**BEFORE THE BOARD OF PATENT APPEALS
AND INTERFERENCES**

Application Number: 09/609,163
Filing Date: June 30, 2000
Appellant(s): FISCHHELL ET AL.

EXAMINER'S ANSWER

This is in response to the appeal brief filed 9/25/2002 and Applicant's response
filed 5/29/2003.

As to claim 50, HESS et al reference (Fig. 4 shown below) discloses a stent made of stainless steel (abstract, line 5).

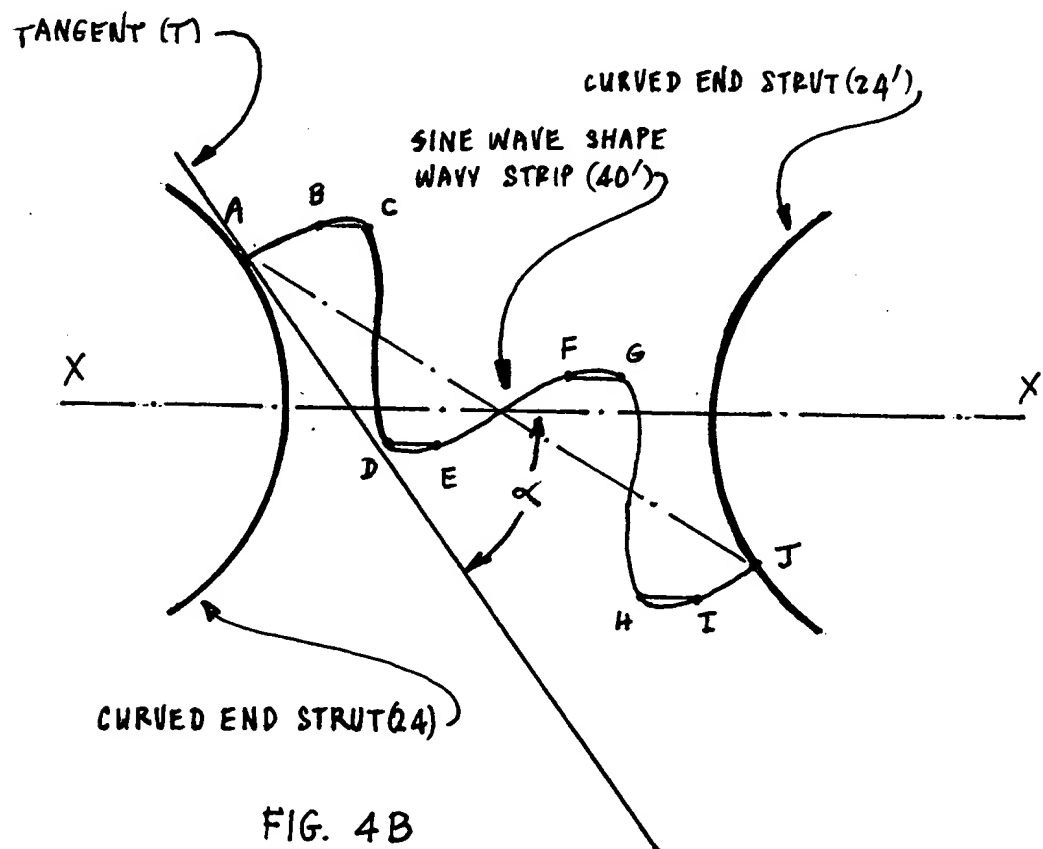
The stent illustrated in Fig. 4 includes curved end struts 24 connected to associate curved end struts 24 by flexible links 40 or **so called wavy strip 40** by HESS (HESS, page 8, lines 10-27). The connecting point of each flexible link or **wavy strip 40** to a curved end strut is offset from the center point of the curved end strut 24. Referring to page 11, lines 10-13, Figs. 12a-b, and claim 2, HESS discloses that flexible links or **wavy strips** can have various configurations such as a sine wave shape as shown in Fig. 12a -b having one or more repeating portions 102. In view of these explicit teachings, at least it would have been obvious to one of ordinary skill in the art at the time the invention was made to **replace** flexible links or **wavy strips 40** illustrated in Fig. 4 with **wavy strips** of sine wave shape of two repeating portions 102 as

In regard to claim 51, each flexible link 40 of HESS appears to be thinner than each curved end struts 24. Should the Applicant contends that HESS et al does not clearly teach each flexible link/wavy strip 40 having a width less than a thickness of each curved end strut, attention is directed to the RICHTER-5,807,404 reference which

FIG. 4B

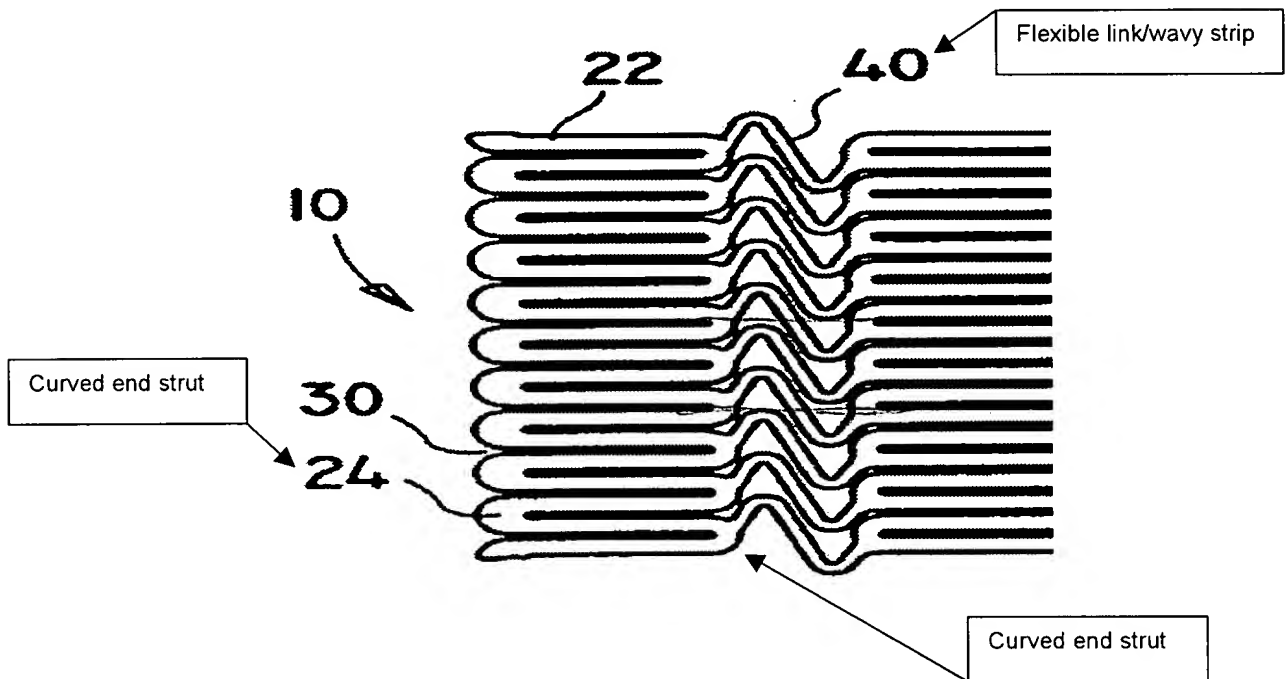
shown in the following Fig. 4B so as to make the stent (10) flexible and suitable for a more tortuous path in a vessel as disclosed by HESS (page 9, lines 1-13):

Referring to Fig. 4B constructed by the Examiner according to HESS teaching, claim 50 of the present invention is copied and interpreted as below:

A stent (10) as shown in Fig. 4/4B suggested by HESS in the form of a generally tubular structure having a longitudinal axis (XX), the stent (10) comprising;

a plurality of circumferential sets of strut members (22, 24) that extend in a generally circumferential, ring-like pattern around the stent's longitudinal axis (XX) with each circumferential set of strut members comprising a plurality of curved end struts (24), the curved end struts (24) being substantially curved across their entire length;

a plurality of flexible links/**wavy strips** (40') with each flexible link/**wavy strip** (40') being fixedly attached to two adjacent circumferential sets of strut members (22, 24) and each flexible link/**wavy strip** (40') having a proximal end (A) and a distal end (J) with a line (AJ) drawn through the proximal and distal ends of the flexible link/**wavy strip** (40') lying transverse to the stent's longitudinal axis (XX), each flexible link/**wavy strip** (40') having at least four generally longitudinal extending curved segments (BC, DE, FG, HI) that each have a proximal end (B or D or F or H) and a distal end (C or E or G or I) with a line (BC or DE or FG or HI) joining the proximal end and distal end of each curved segment being generally parallel to the stent's longitudinal axis (XX), the curved segments (BC, DE, FG, and HI) being connected together in series by three generally circumferentially extending segments (CD, EF, GH) of

approximately equal length; and the stent (10) being further characterized by having the outermost curved segment (AB) of each flexible link/wavy strip (40') connected to each "curved end strut" (24)*⁷ at a point (A) thereon, the tangent (T) to the curved end strut (24) at which point (A) being at an acute angle (alpha) with respect to the stent's longitudinal axis (XX) as taken in the direction of the curved end strut (24', see above Fig.) that is opposite the curved end strut (24) onto which the outermost curved end segment (AB) is attached. *Note that in the claim, the wrong term "curved end segment" is used instead of the right term - curved end strut - as used in the above rejection.

As to claim 54, the embodiment taught by HESS and illustrated as Fig. 4B above shows flexible links/wavy strips (40') of "N" shape comparable to the "N" shape labeled as "44" in Fig. 7 of the present invention.

1. Referring to the Applicants' arguments, page 4, lines 18-20 and page 5, lines 16-18), the Applicants asserted that substitution of a sine wave wavy strip 40' (shown in Fig. 4B above) suggested by HESS claim 2 to repeat (for example, two sine wave shown in Fig. 12a, HESS) for a wavy strip 40 (shown in Fig. 4, HESS) necessarily requires further modification of the wavy strip 40' so as the modified HESS stent (as shown in Fig. 4B above) would read on claim 50 as now recited.

On the contrary, a replacement of wavy strips 40 with wavy strips 40' as illustrated in Fig. 4B above does not require any further modification of wavy strips 40' (two repeating of sine wave 102) so as the stent shown in Fig. 4B reads on claim 50. As pointed out in the above rejection of claim 50, each and every limitation recited in claim 50 is met by the stent shown in Fig. 4B above.
